A303 Amesbury to Berwick Down

TR010025

Deadline 2 8.10.4 Alternatives (AL.1)

4 Alternatives (AL.1)

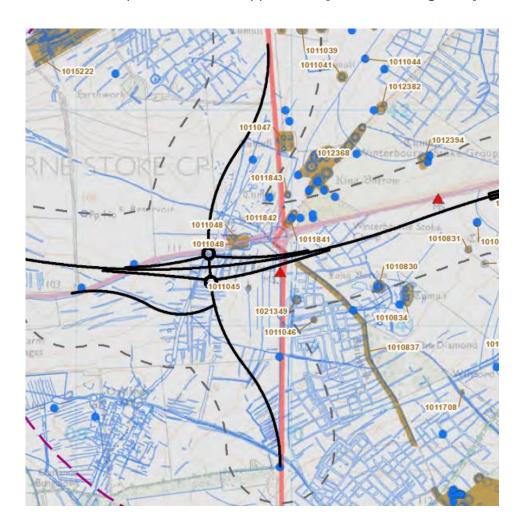
Please explain in further detail why Option 1 would offer a reduced benefit to the OUV of the WHS in comparison to Option 3.

1. Option 1 reflects the junction alignment as proposed in the Stage 2 Scheme Assessment Report, Volume 7, Appendix E [REP1-029, Figure 8].

- Excerpt from Figure 8 from the A303 Stonehenge Amesbury to Berwick Down Scheme Assessment Report (Volume 7) Appendix E Historic Environment Assessment [REP1-029].
- 3. Option 1 would distance the sight and sound of traffic at the junction from the Winterbourne Stoke Crossroads Barrows, including the Neolithic Longbarrow. This would be a benefit in terms of removing the existing adverse impacts of the A303 and A360 on the setting of the barrow group and on Attributes 2-3 and 5-6

- that convey the OUV of the WHS. The option, however, required land-take from the WHS for the slip roads for the junction as can be seen in Figure 8 above.
